DATA EAST PINBALL, INC.

To: Bill Sowash
From: Data East Pinball Service Department
Date: February 20, 1991
Subject: Washer added to Simpsons Towers

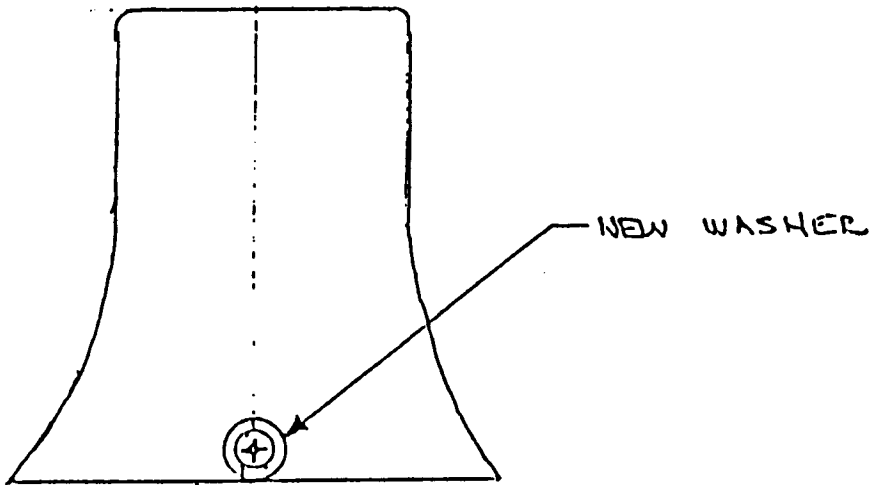
In an effort to better secure the plastic "cooling tower" on top of the pop bumpers, place a flat washer between the plastic and the head of the screw on both sides.
Part No. of the washer is 242-5001-00. (3/8OD X 5/32ID).
